HONG KONG FIRE SERVICES DEPARTMENT

TECHNICAL GUIDANCE

**Application of BS 5839-1:2017 (Incorporating Corrigendum No. 1)
Fire Detection and Fire Alarm Systems for Buildings in Hong Kong**

June 2021

**The following new Clause 12.2.2 m)** should be added

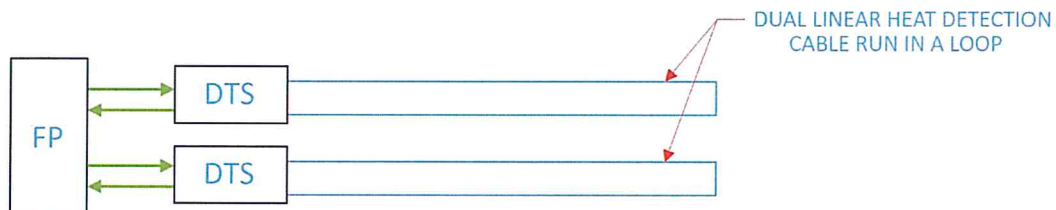
"Linear Heat Detectors

(ii) For protection area exceeding 2,000 m², duplicate linear heat detection cables with its associated control panels, should be provided with configuration as recommended by manufacturer, to form a complete redundancy as shown in figure below.”

Note: This clause is to add requirements on linear heat detectors.

Figure 1 – For Detectors inside Floor Voids

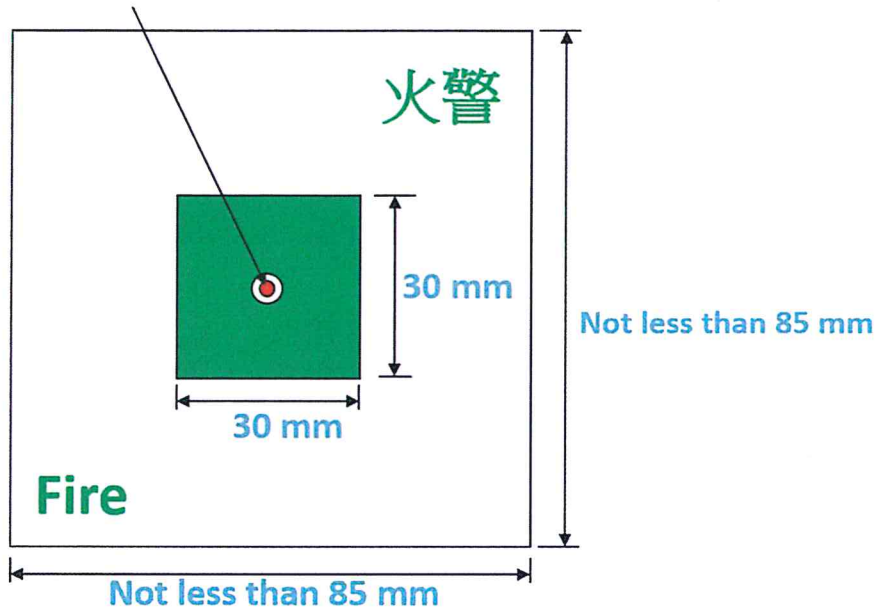
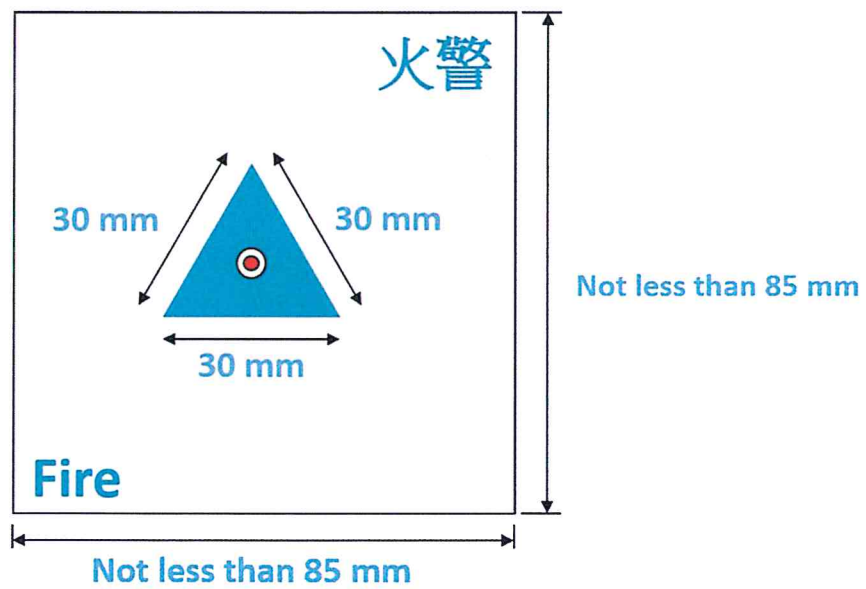
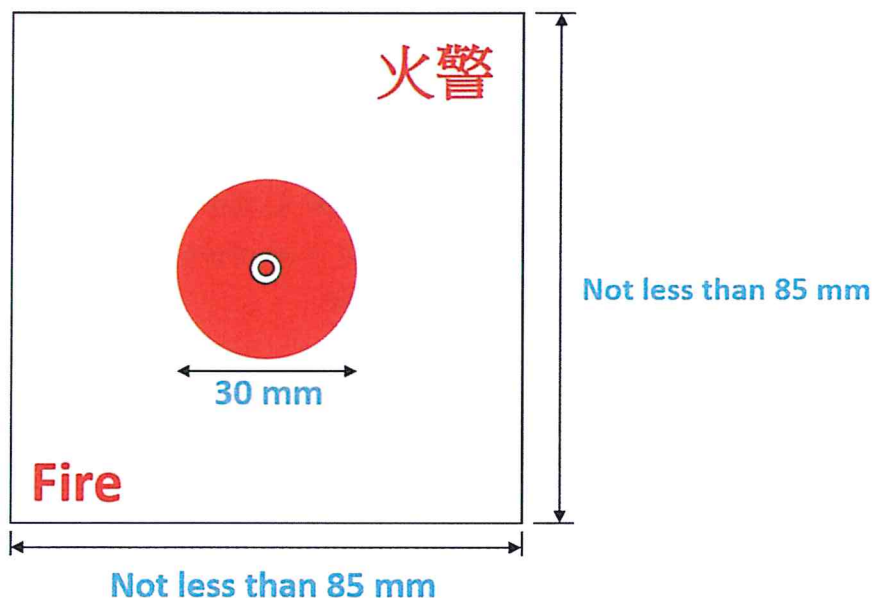
Clause 13.2.5 Para. 1 should be revised and read as

1. The colours for the plate, the graphic pattern and the wording should be suitably chosen so as to provide luminous contrast for the purpose of clear identification at a distance.
2. The indicating lamp should be red in colour.
3. The height of English letters and Chinese characters should not be less than 10 mm and 15 mm respectively or should follow the latest specifications issued by the Director of Fire Services from time to time.
4. The designs of remote indicating lamp plates for detectors in respective locations, i.e. floor voids, ceiling voids and lockable rooms, should follow the relevant graphic pattern illustrated below:-
 - (a) Figure 1 – For Detectors inside Floor Voids
 - (b) Figure 2 – For Detectors inside Ceiling Voids
 - (c) Figure 3 – For Detector inside Lockable Rooms”

Note: This clause is to meet local requirements for remote indicator labelling and clarify the requirement for the provision of remote indicator. For addressable system, remote indicator lamp is not required.

Figure 11 c) – Ceilings : Cells formed from joists [see 22.3k) and 22.3l)]

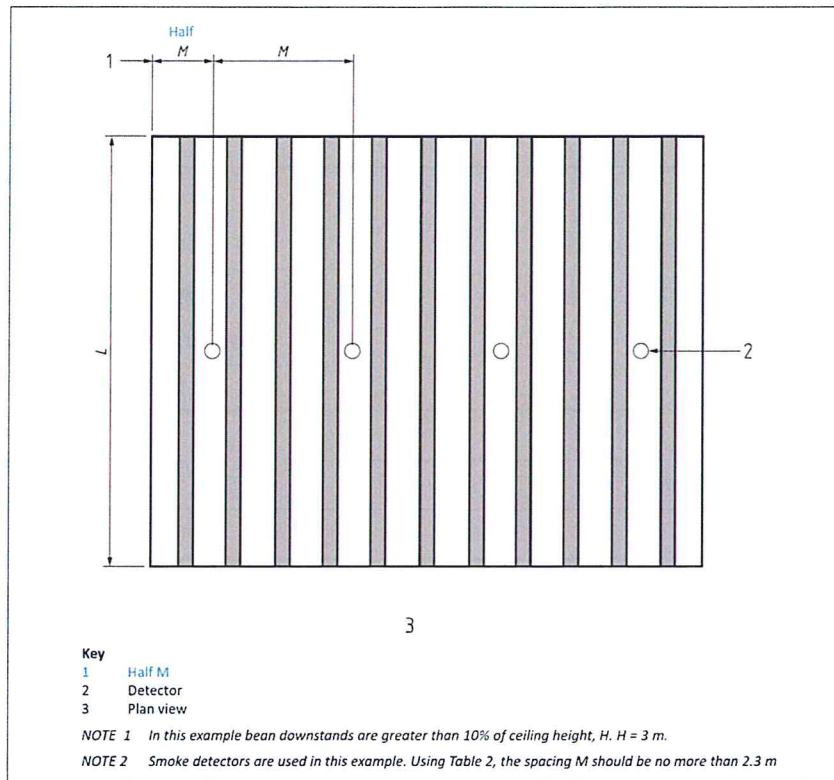
**Figure 11 c) of Clause 22.3 l)** should be revised and read as
